| NOISE—"CHUCKING/SQUEAKING/CREAKING" COMING FROM REAR DOORS WHILE DRIVING OVER BUMPS AND/OR DURING HARD TURNS WHILE STOPPING | Article No. 00-5-5 |

**FORD:** 1999-2000 RANGER

Figure 1 - Article 00-5-5

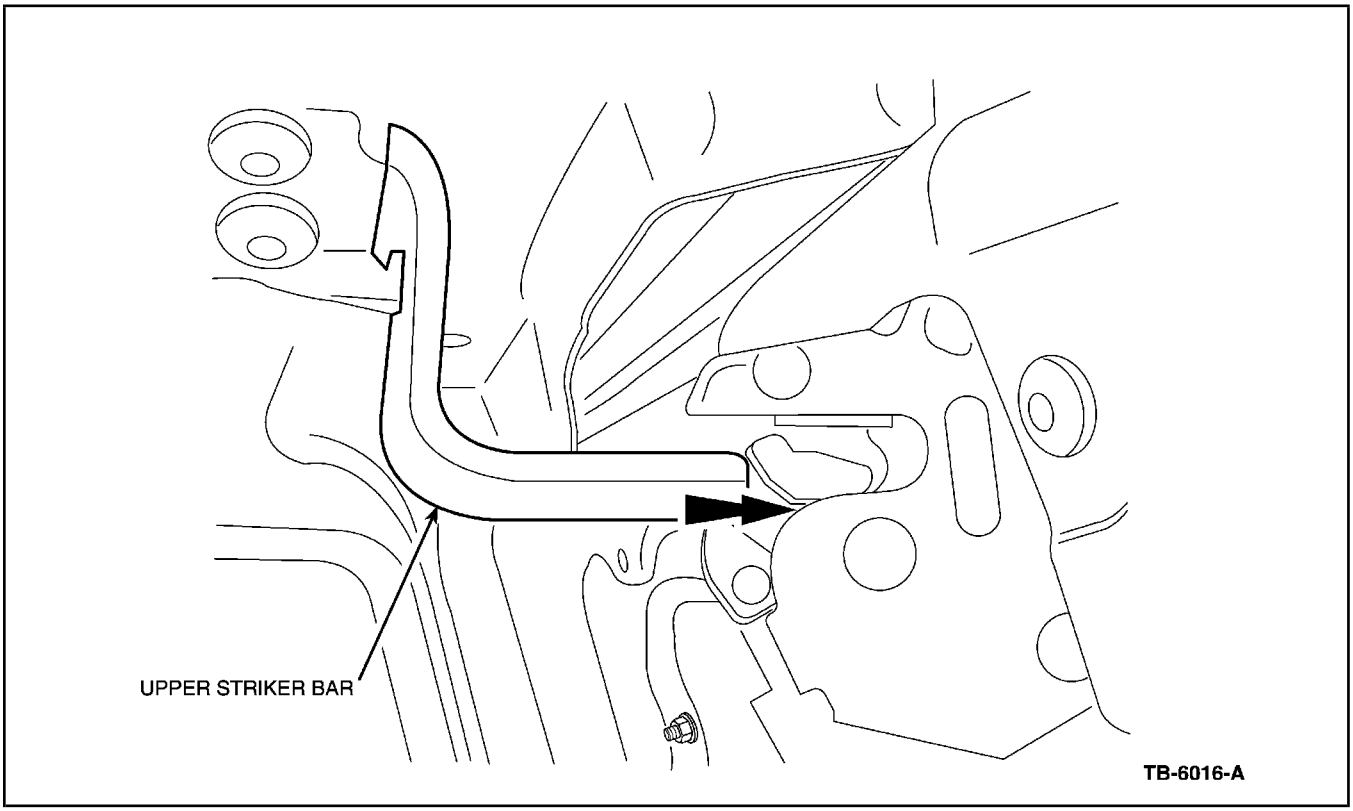
A "chucking/squeaking" and/or "creaking" noise may be heard from the rear doors while driving over bumps and/or during a hard turn while stopping. This may be caused by the rear door striker bar positioned incorrectly.

Correctly position striker bar. Refer to the following Service Procedure for details.

1. Verify chucking, squeaking, and/or creaking sound(s) are present while driving on non-smooth surfaces (e.g. gravel/rough roads). The sound may also be present under a hard turn (stop-to-stop) condition and/or when the vehicle is in a body-flex situation (i.e. turning in parking lot or driveway).
2. If noise(s) are present, determine if the rear doors' upper striker bars are positioned correctly (Figure 1). The upper striker bar must meet the center of the rear door locking-latch assembly as shown in Figure 1.
3. If not, lightly tap upper striker bar with a rubber/plastic mallet or equivalent, so it is positioned correctly as shown in Figure 1.
4. Verify fix with road test by driving over rough or non-smooth surfaces.
